Palo Verde Nuclear
Generating Station

**Subject: Palo Verde Nuclear Generating Station (PVNGS)
Units 1, 2, and 3
Docket Nos. STN 50-528, 50-529, and 50-530
Request for Amendments to Technical Specification (TS) 3.5.5,
Refueling Water Tank (RWT), to Increase the RWT Minimum Water
Level for Units 1 and 3 and Incorporate Editorial Changes for
Units 1, 2, and 3**

Subject: Request for Amendments to Technical Specification 3.5.5, Refueling Water Tank (RWT), to Increase the RWT Minimum Water Level for Units 1 and 3 and Incorporate Editorial Changes for Units 1, 2, and 3

FIGURE 3.5.5-1
Minimum Required RWT Volume

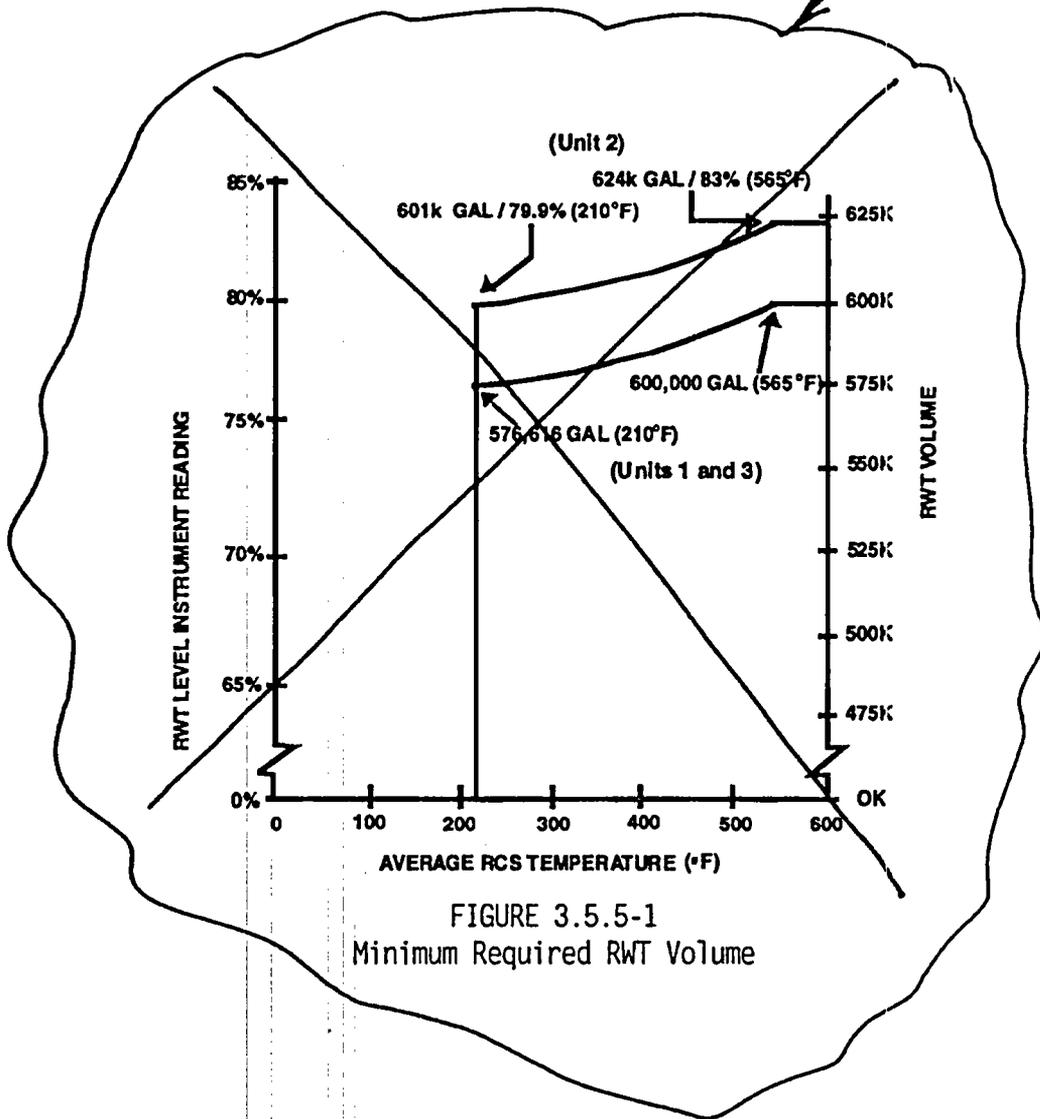
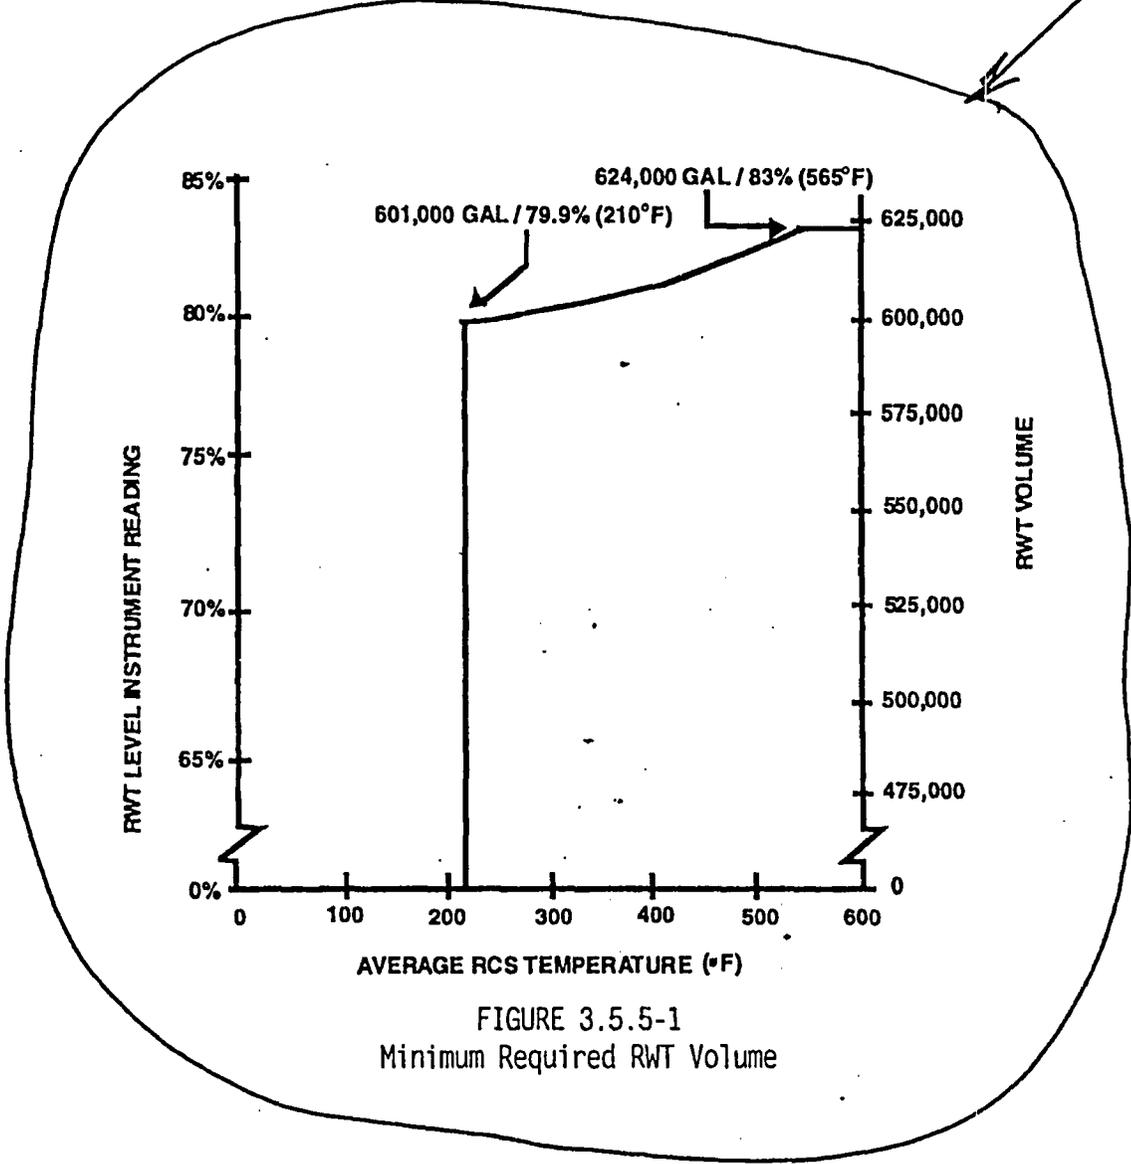
As indicated in the attachments to this evaluation, the proposed amendments involve a substantive component and an editorial component. The substantive component entails the proposed revision of TS 3.5.5 for Units 1 and 3 to raise the required minimum RWT level indications and the corresponding water volume values shown in TS Figure 3.5.5-1 by 3 percent. This change revises the minimum level indications and the corresponding water volumes used to determine operability of the RWT from 210 °F through 600 °F (i.e., to ensure that there is adequate volume available for the design functions of the RWT). This change will ensure that there is adequate water volume in the containment to meet the functional requirements of the ESF pumps and the containment sump strainers for applicable design basis accidents and break scenarios. The RWT water volumes corresponding to the TS Figure 3.5.5-1 level instrument readings include margin to ensure the minimum required RWT water volumes are maintained available.

The editorial component of the proposed amendment serves to provide consistent formatting of the volumetric values provided in TS Figure 3.5.5-1 for PVNGS Units 1, 2, and 3. Specifically, TS Figure 3.5.5-1 currently uses two different formats to designate the volume information provided. It either provides only the whole digits above one thousand followed by a "K" to designate a multiplier of one thousand (e.g., 600K), or the full volume numbers are written out (e.g., 600,000). For consistency, the volume information provided in the figure is changed such that it is presented in full number format.

Replace with ATTACHED Figure

~~PALO VERDE UNITS 1 AND 3~~
~~PALO VERDE UNIT 2~~
UNITS 1, 2, 3

~~AMENDMENT NO. 117, 127~~
~~AMENDMENT NO. 127, 169~~

Replacement Figure For Figure 3.5.5-1

FIGURE 3.5.5-1
Minimum Required RWT Volume

FIGURE 3.5.5-1
Minimum Required RWT Volume

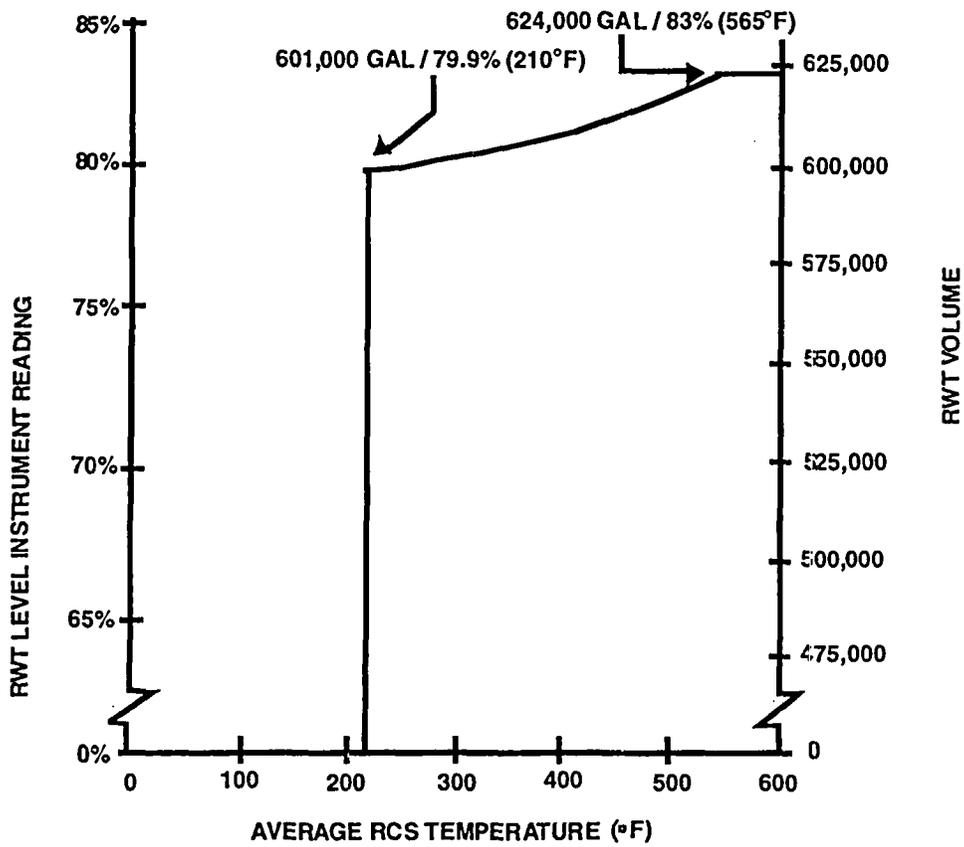
**Page:
3.5.5-3**
